PERCOLATION TESTING

HOWARD COUNTY HEALTH DEPARTMENT  
BUREAU OF ENVIRONMENTAL HEALTH  
P.O. BOX 476 ELLICOTT CITY, MARYLAND 21043  
TELEPHONE: 461-9933

PROPERTY OWNER Bernard Heidelberg  
ADDRESS 7036 Mink Hollow Rd PHONE \_\_\_\_\_

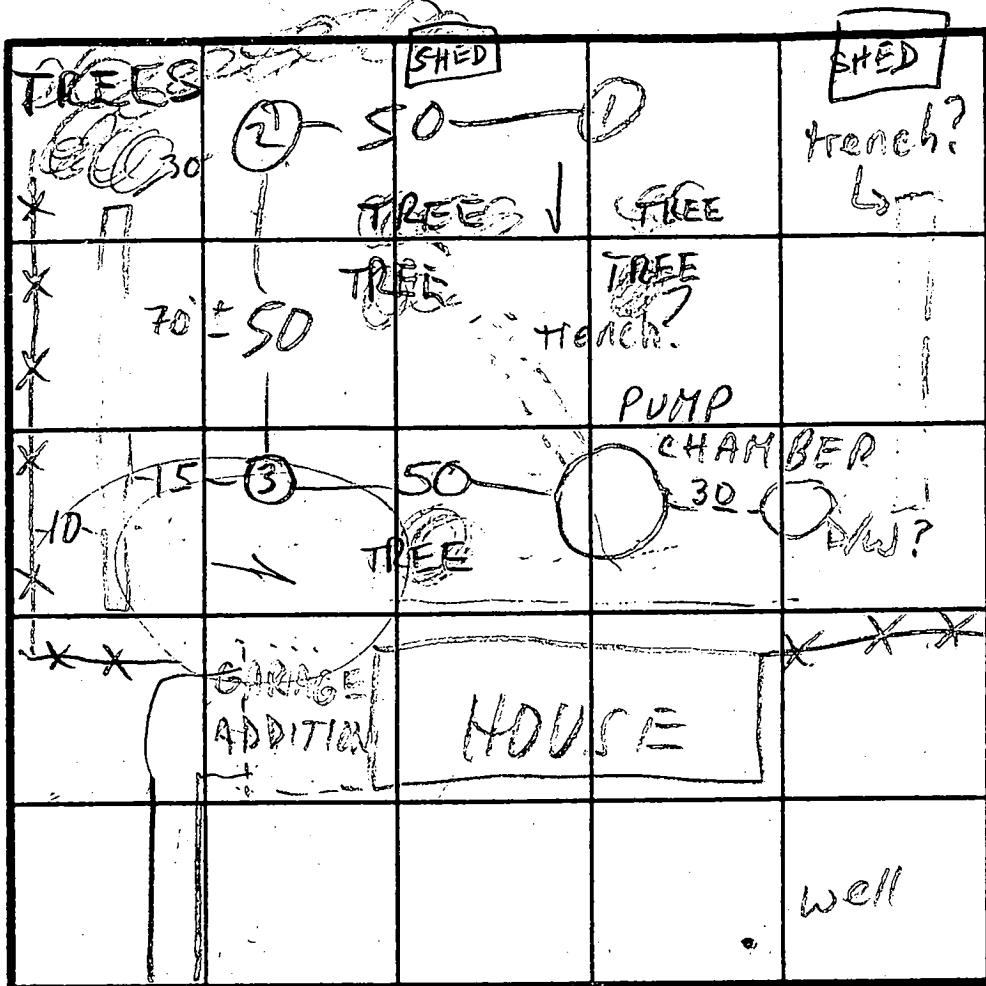
REASONS FOR REJECTION OR HOLDING 8/7/89- Proposed garage is lower than area tested for the repair. The repair area has water table problems which will require close interpretation in future repairs. S. Abel for MK

REMARKS SHALLOW SYSTEM ONLY OR LOWER THAN GARAGE LEVEL ③  
 REPAIR WILL REQUIRE SPECIAL REVIEW DUE TO H<sub>2</sub>O TABLE  
 TYPE OF SOIL PROPOSED GARAGE HAS NO IMPACT ON REPAIR  
 RECOMMEND APPROVAL OF BP FOR PROPOSED GARAGE  
 TESTED BY NO FUTURE REPAIR AREA LOST MR 8/7/89 ALSO PRESENT
